Access Compliance Report

Public Rights-of-Way

Intersection ID: 53621	Main Street: JIMMY_OEHLER_RD	Cross Street: OEHLER_BRIDGE_DR	Location: E
ADA ID: 1A922018E967	Ramp Type: Perp	Initial Pass/Fail: Pass	Overall Compliance: No
		Severity Score: 0

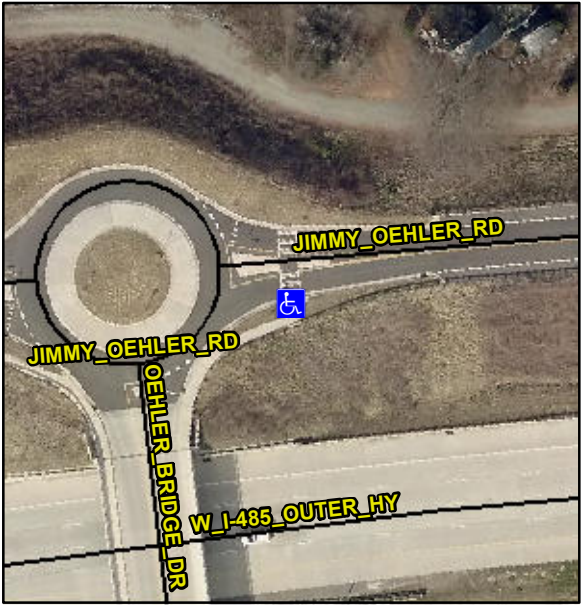
Codes/Mitigation Info/Possible Solution		Field Measurements/Component Compliance			
	Possible Solutions:				
	Remove & Replace Detectable Warning System.				
	Surveyor Notes:				
	N/A				
	PROW/ADA:				
	R305.2				
Street 1 Name	JIMMY OEHLER RD				
Stop Condition-Street 2	YieldSign				
Street 2 Name	N/A				
Stop Condition-Street 1	N/A				
Total Cost:		\$	800.00
